A meeting of the Development Control Committee will be held at Bromley Civic Centre, Stockwell Close, Bromley, BR1 3UH on **THURSDAY 30 NOVEMBER 2023 AT 7.30 PM**

<b>Committee Date</b>	30 <sup>th</sup> November 2023	
<b>Address</b>	2-4 Ringers Road and 5 Ethelbert Road Bromley BR1 1HT	
<b>Application number</b>	21/05585/FULL1	<b>Officer</b> Agnieszka Nowak-John
<b>Ward</b>	Bromley Town	
<b>Proposal (Summary)</b>	Demolition of existing buildings and construction of a mixed use development comprising residential units, ancillary residents' facilities (including co-working space) and commercial floor space (Use Class E) across two blocks, along with associated hard and soft landscaping, amenity spaces, cycle and refuse storage (Revised scheme incorporating a second stair into Block A and Block B, internal layout and elevational changes, and changes to the on street parking bays and footpath along Ringers Road and Ethelbert Road).	
<b>Applicant</b>	<b>Agent</b>	
Ringers Road Properties Ltd	Mr Mark Batchelor 4TY Planning Gainsborough House 59-60 Thames Street Windsor SL4 1TX

<b>RECOMMENDATION</b>	<b><u>Planning Permission be Refused</u></b>
-----------------------	--

Fig.6 Proposed Typical Site Plan.

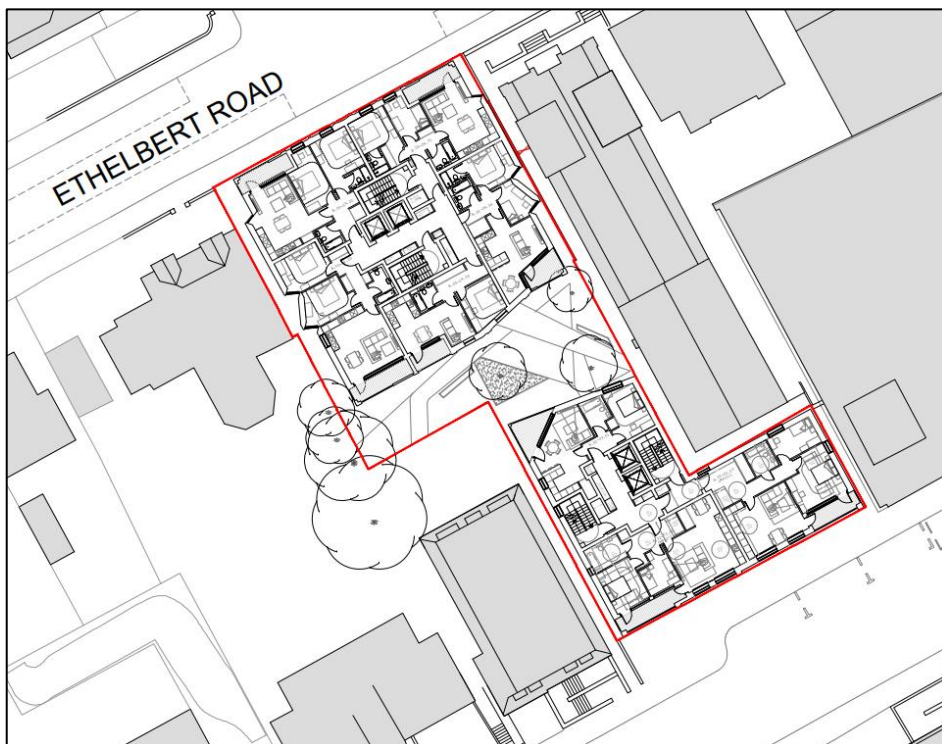
6.3.7 Officers do not agree that the additional flank windows introduced in the latest revision should be regarded as providing a genuinely dual aspect because they would offer highly constrained outlook owing to the presence of the flank walls of adjoining buildings and should neighbouring sites come forward for development, the number of units with unacceptably poor outlook would likely to increase. At the lower levels (floors 1-3) of Block A, a number of 'dual aspect' units would feel like single aspect homes, including the north facing units facing the rear of Block B. In terms of Block B, the quality of the living experience for residents of the single aspect/'enhanced single aspect' north facing homes and those facing the rear of Block A would be oppressive, feeling hemmed in and unacceptably restricted (Fig 6).

6.3.8 In officers view, the extent of the revisions proposed is considered to be minimal and tokenistic, as the enlarged/additional glazing indicated on the revised plans would do little to address the issue of poor-quality outlook. This issue is a consequence of building up to the boundary with minimal separation distances to neighbouring buildings and within the development itself, in order to prioritise quantum over quality; and is symptomatic of an overdevelopment of the site.

Fig.8 View A.

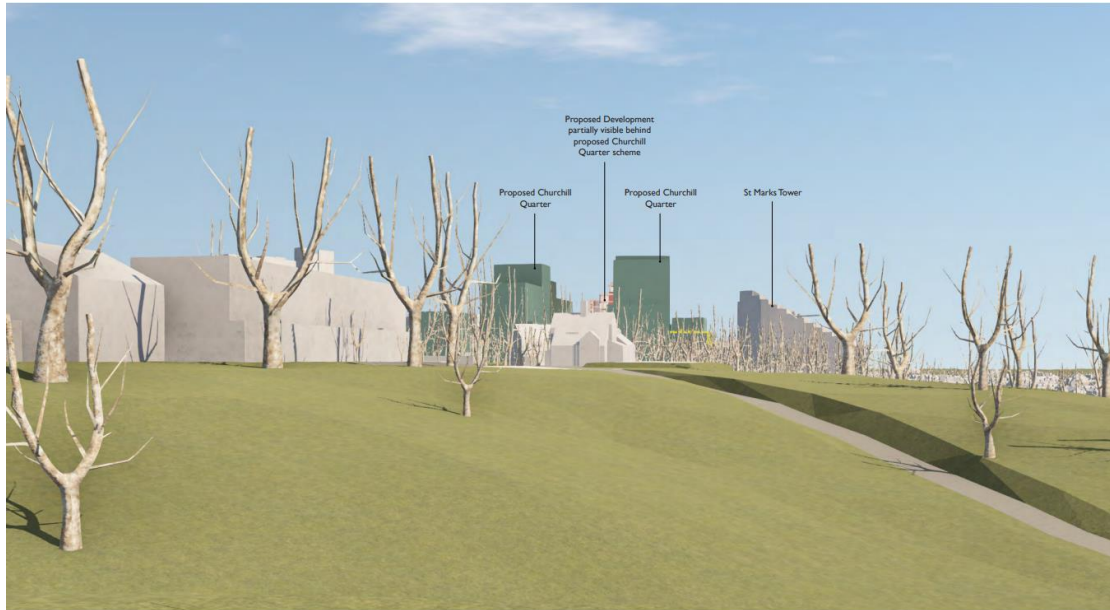
6.4.27 The views include redevelopment proposals for the neighbouring Churchill Quarter site, along with height and massing indicated within the now obsolete draft Site G/10 masterplan ('development zone 2 and 3'). Members are advised that the application for the Churchill Quarter scheme has now been withdrawn, therefore its scale and massing is no longer a material planning consideration. Consequently, the views provided illustrate a hypothetical context which differs considerably to the existing town centre skyline, suggesting that the proposed development would sit more comfortably within the wider context (and appear less prominent) than it actually would i.e. indicating that the buildings would only be partially visible behind the Churchill Quarter scheme (View A – Fig.8) and visually subservient in Views B, D and E.

6.4.28 The topography/elevated position of the site would further increase the visual prominence of the buildings and the perception of height, particularly in views from the west. The buildings would also coalesce in many views reading as a single mass due to their minimal separation distance. In long-range views the buildings would equal the visual prominence of St Mark’s Square (currently the tallest building in Bromley Town Centre) as indicated in View A. The mid-range views shown below on Figs 9 and 10 (Views B and C), demonstrate a significant visual impact on the lower-rise residential context when assessed against the existing condition and their acceptability is dependent upon neighbouring sites being developed at a scale and height similar to that which is being proposed in order to mitigate/offset the visual impact.

Fig.12 Viewpoint G (Excluding and including allowed appeal at 66-70 High Street).

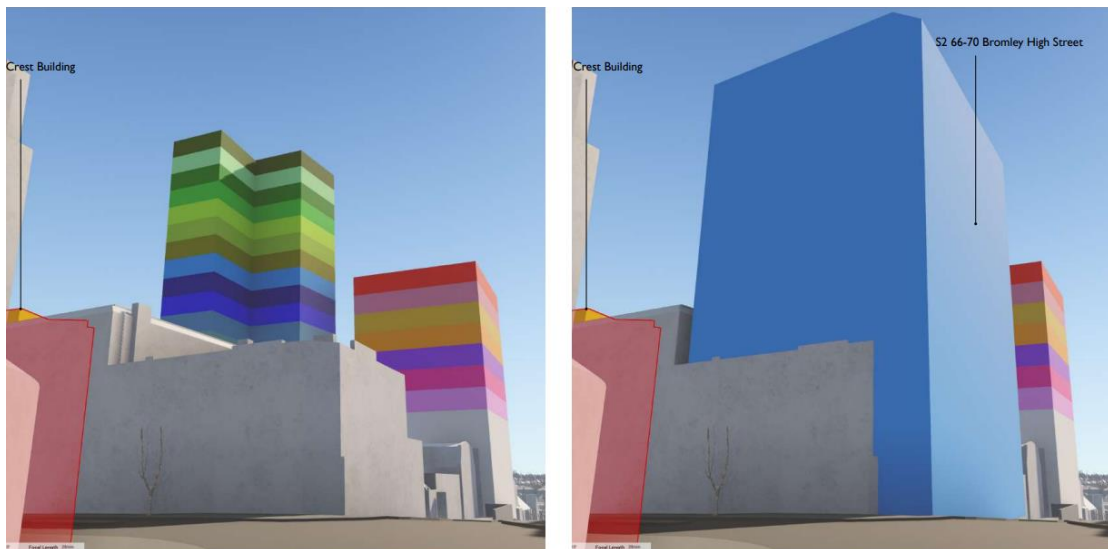
6.5.16 The TVIA includes two unverified views of the proposals from within the Conservation Area – viewpoints F and G shown below (Figs 11 and 12) and also views C, L, and M just outside. The TVIA concludes that assessment demonstrates that the proposed development would not adversely affect the key views and vistas from the High Street and the Conservation Area.

6.5.17 Although officers acknowledge that the topography of the location which falls away from the High Street (and the boundary of the conservation area) towards the site would help to reduce the impact of the proposed buildings, both blocks would be visible, extending above buildings along the High Street. Officers consider that the proposed height, scale and massing of the proposal would negatively impact on the setting of the Bromley Town Centre Conservation Area causing visual harm by dominating views within. The views mentioned above demonstrate this impact, with views from the High Street being particularly harmful.

Fig.13 Model of the Proposal.

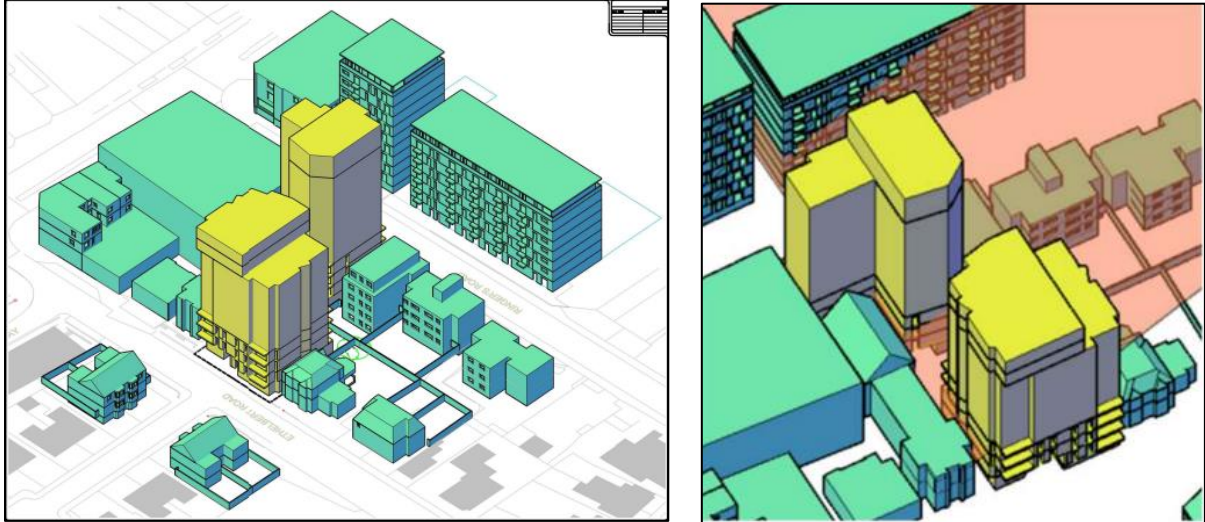
6.6.6 It is further considered that the additional mass of the proposed development in such close proximity to No.6 Ringers Road, together with the loss of the sycamore tree to the rear of the site which currently provides occupiers with a degree of visual screening between the two sites, would result in a poor and uncomfortable spacial relationship, that

would be oppressively intrusive and overbearing for its existing occupants. This is particularly objectionable given that the building in question comprises some single aspect residential units that rely solely on its northern aspect for daylight, sunlight and outlook.

6.6.7 Due to the height, scale and siting of the proposed development in close proximity to the site boundary, concerns are also raised with regard to the resulting relationship with No. 7 Ethelbert Road which would be overbearing for its existing occupants.

Fig.14 Site location and neighbouring buildings assessed.

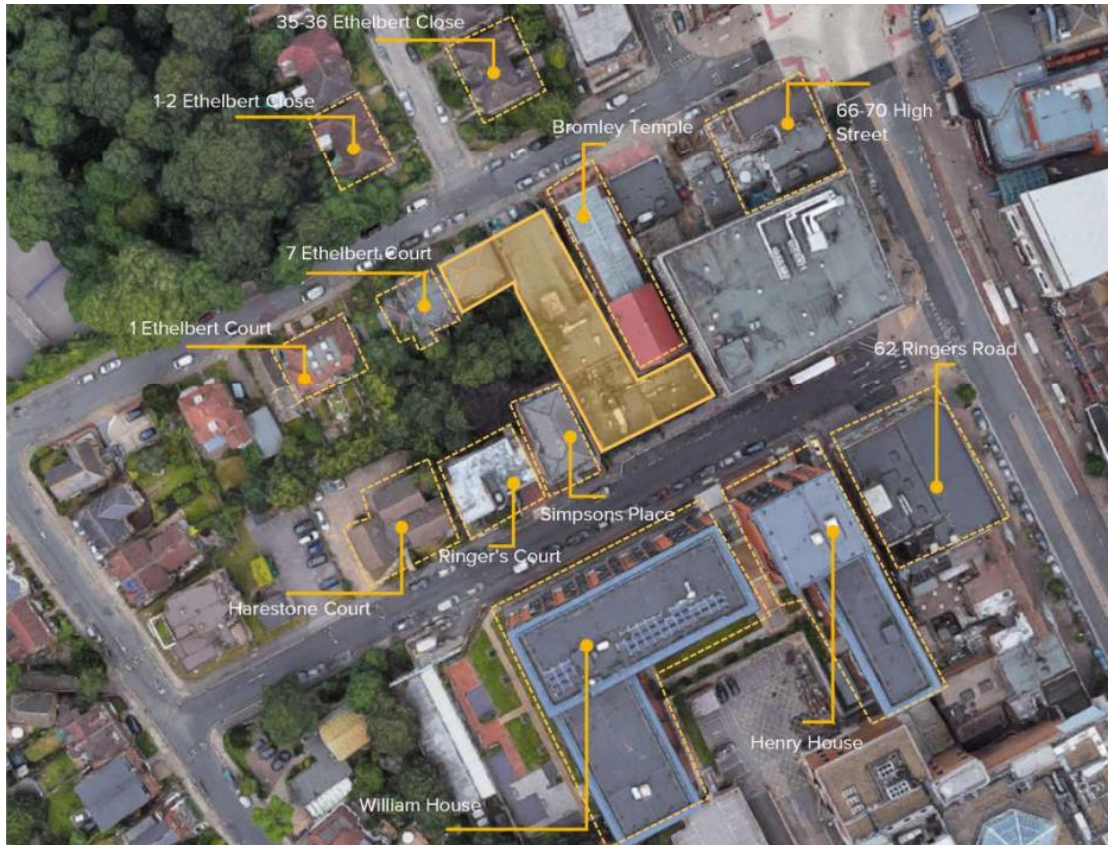
6.6.8 The proposed development would loom over the Salvation Army building (Bromley Temple) with the courtyard area offering little relief from the height, scale and mass of the blocks (Fig.13 above). Reference is made in the submission to the Salvation Army building being part of the allocation with 'obvious development potential' and officers note that the eastern elevation of Block B features angled windows to limit direct overlooking over the church site. It is unclear, however, what consideration was given to the impact the proposal would have on the existing context, except for the conclusion that currently the building is in non-residential use.
